TOWN OF LOS GATOS
PLANNING COMMISSION STAFF REPORT
Meeting Date: May 25, 2016

APPLICATION NO: Architecture and Site Application S-12-103
Subdivision Application M-12-008
Negative Declaration ND-16-001

LOCATION: **341 Bella Vista Avenue** (west side of Bella Vista Avenue, north of Charles Street)

APPLICATION SUMMARY: Requesting approval to merge two lots and to construct a new single-family residence and remove large protected trees on property zoned R-1:8. No significant environmental impacts have been identified and a Mitigated Negative Declaration is recommended. APNs 529-23-015 and 016.

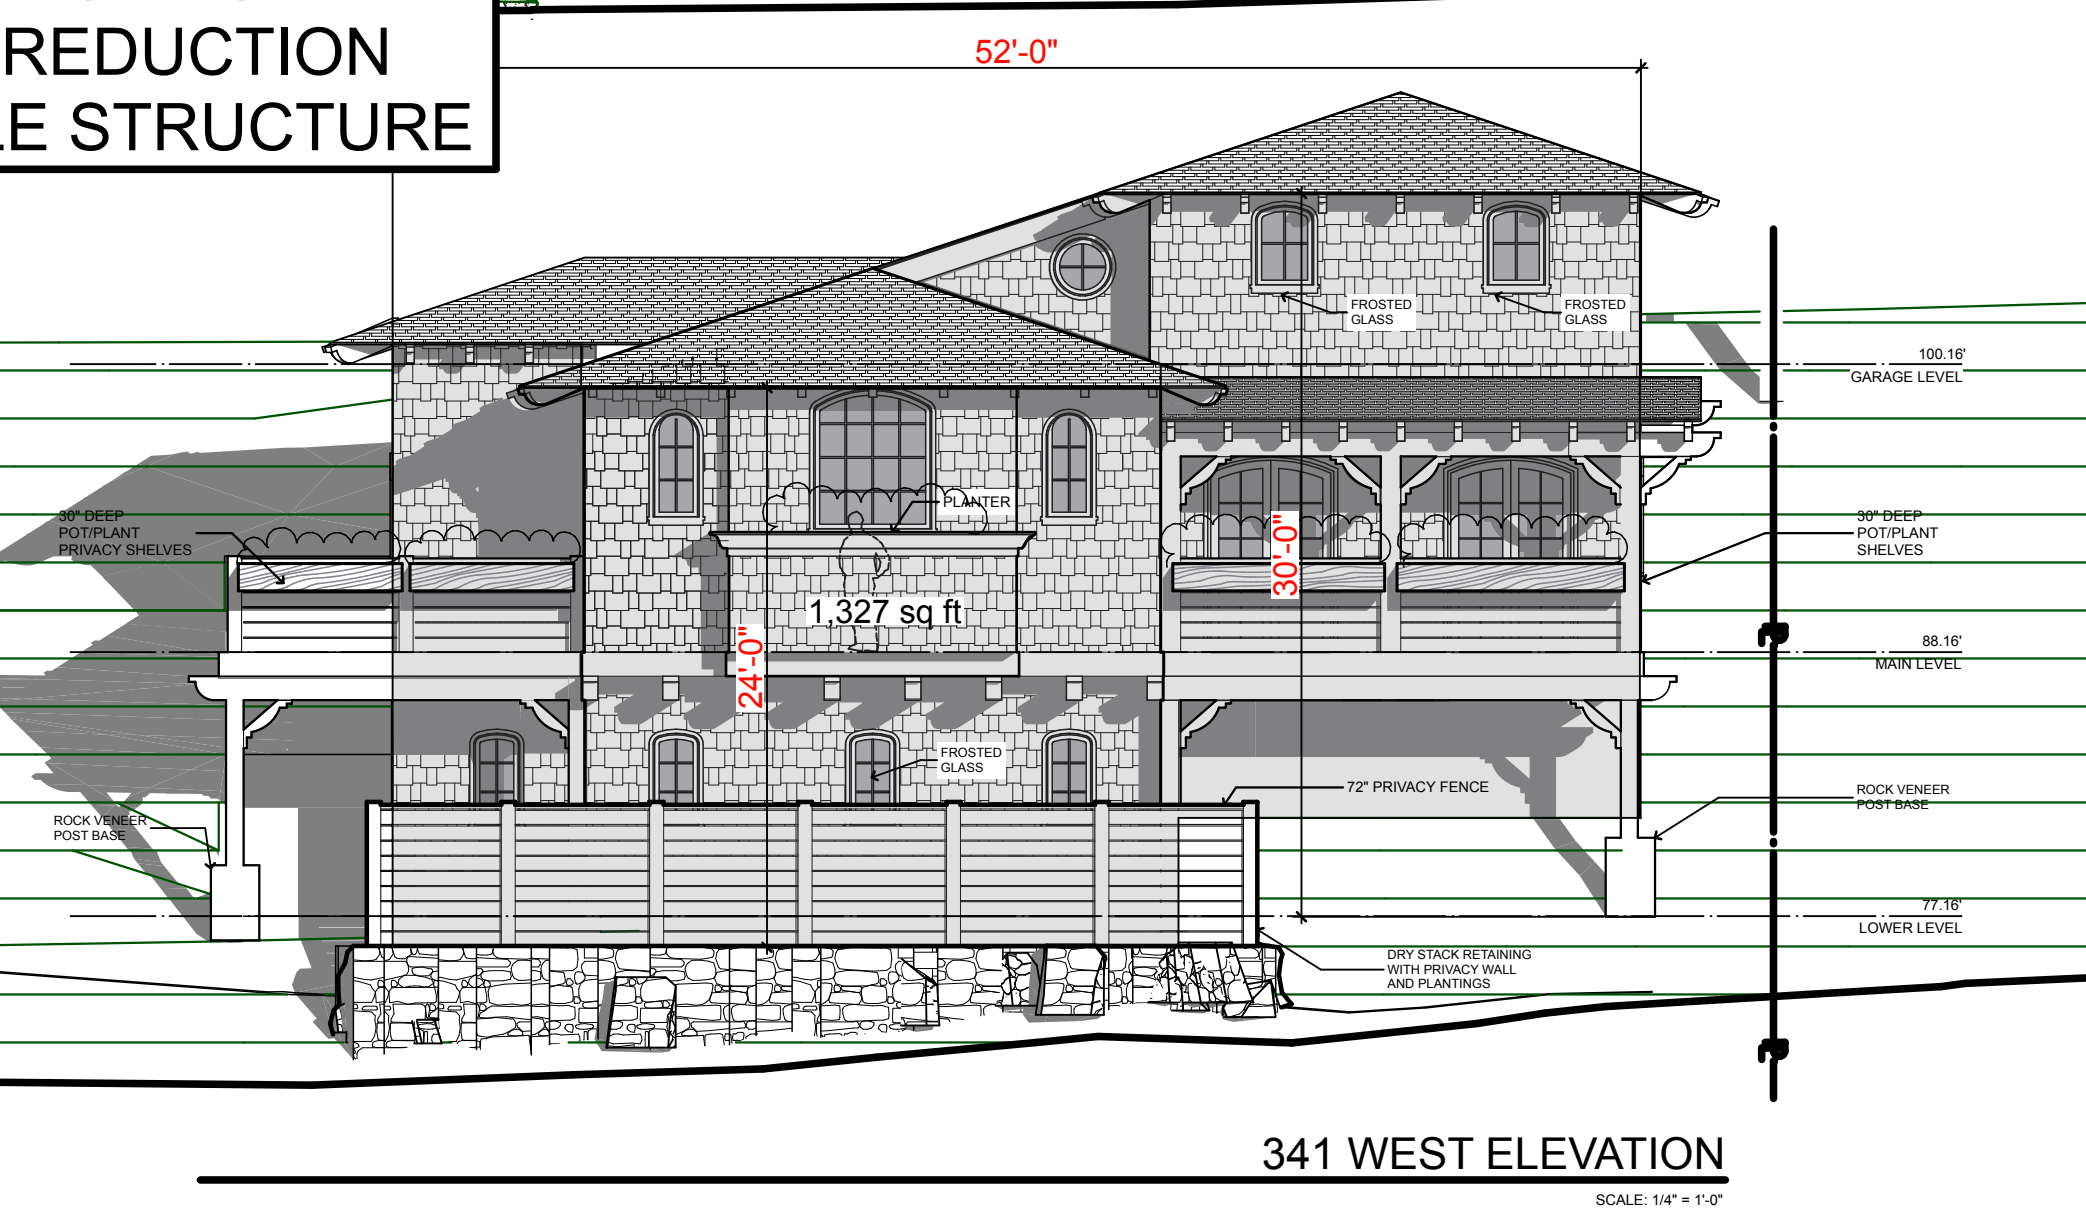
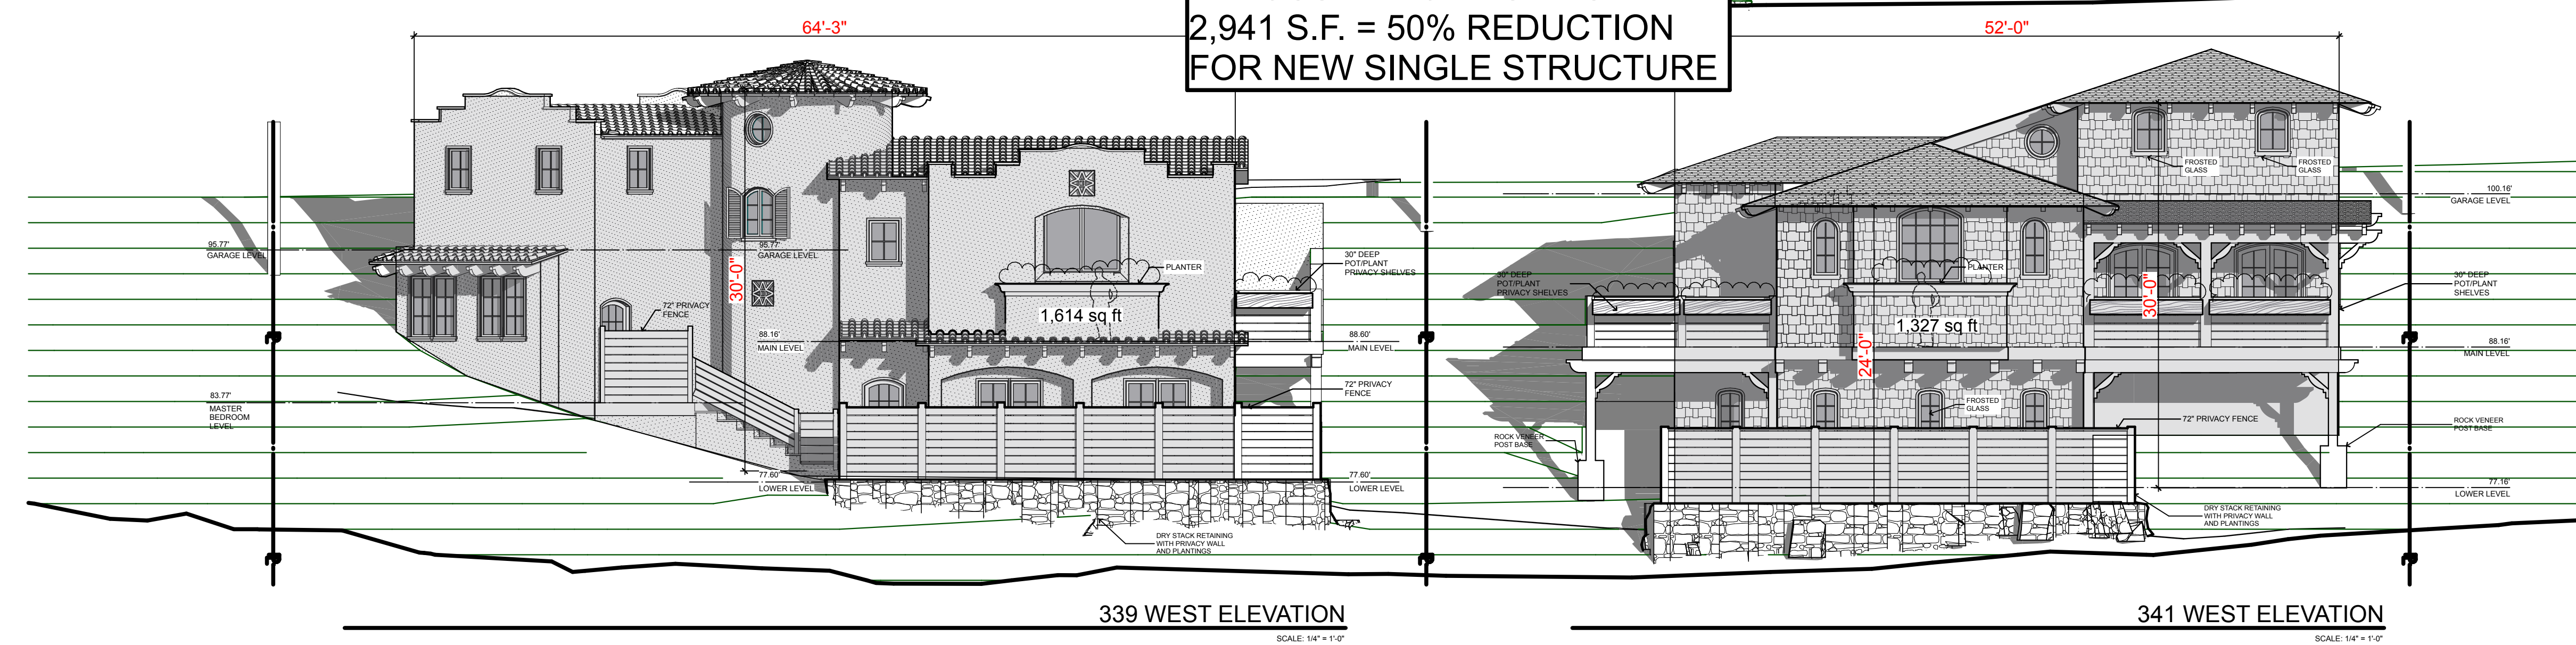
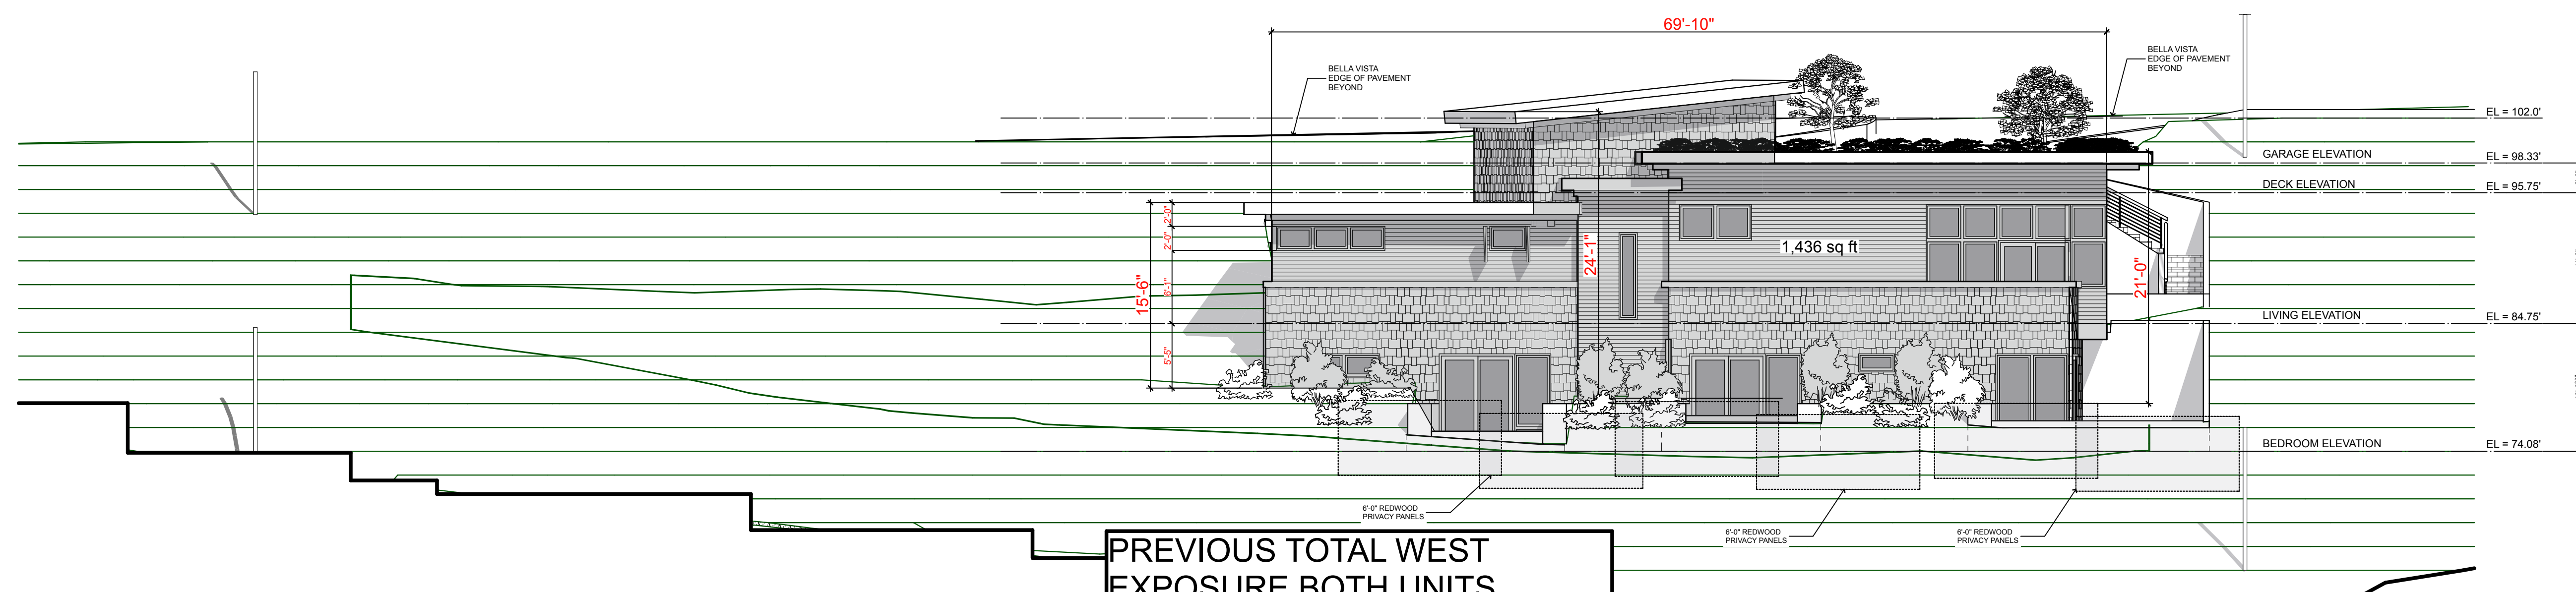
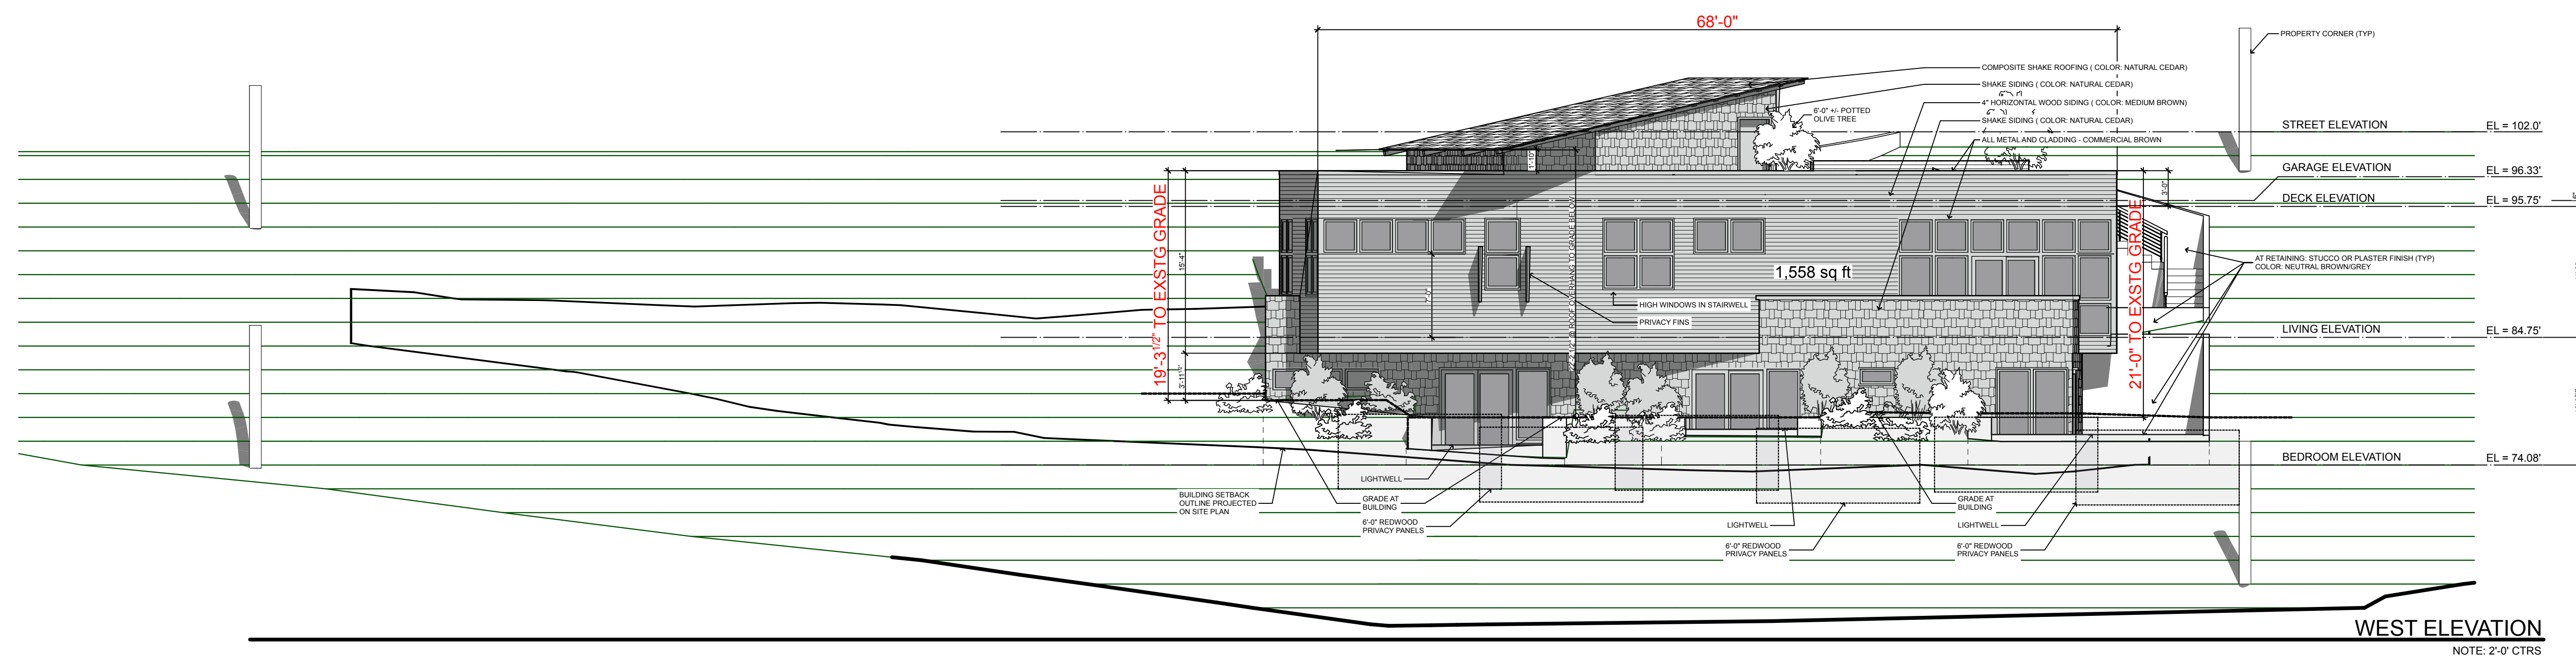
Since the last Planning Commission Hearing, we reviewed the rear elevation and found a way to lower the north corner from 22'6" +/- to 15'6" from top of roof to grade. We also eliminated the 6' cantilevered overhang, reducing the main level square footage by 172 sf to 1106 sf from previous 1278 sf. This increases the rear setback at the north corner from 23' +/- to 29' +/-, and eliminates and additional 120' +/- of wall mass from the rear of the home. The north wall of the house (dining room area) is reduced from 20' +/- to 14' +/- . This reduces height, mass, scale and home square footage relating to the Maggi Court neighbors. The garage has been moved away from the edge of the back of

WEST AREA COMPARISONS

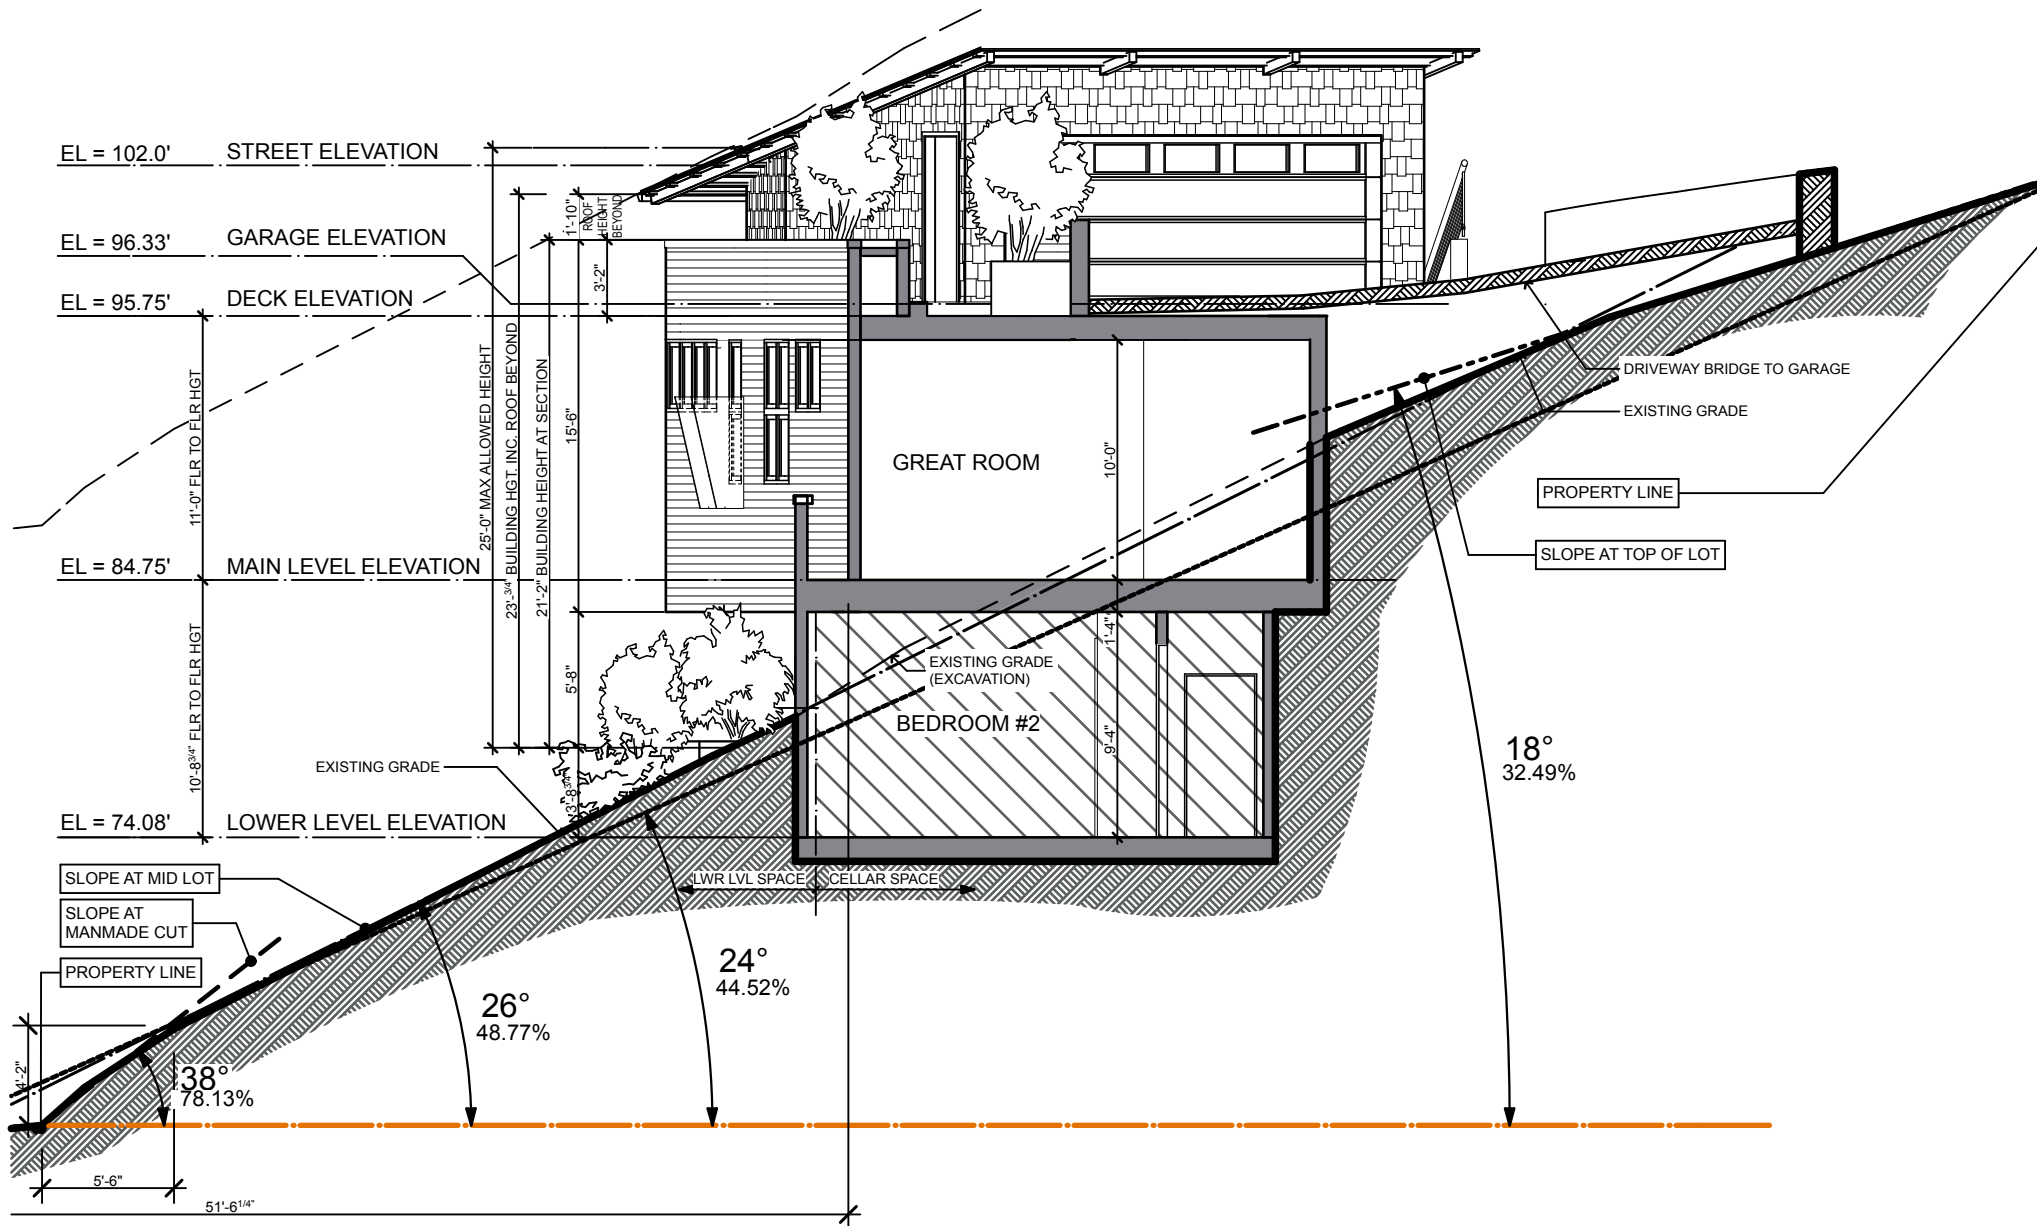
See Exhibit 1 for west elevation massing comparisons between the two home plan and one home plan. As noted below, we have made further revisions to the plans to further reduce height, bulk, mass, and square footage of the home. This new elevation is included for reference and consideration
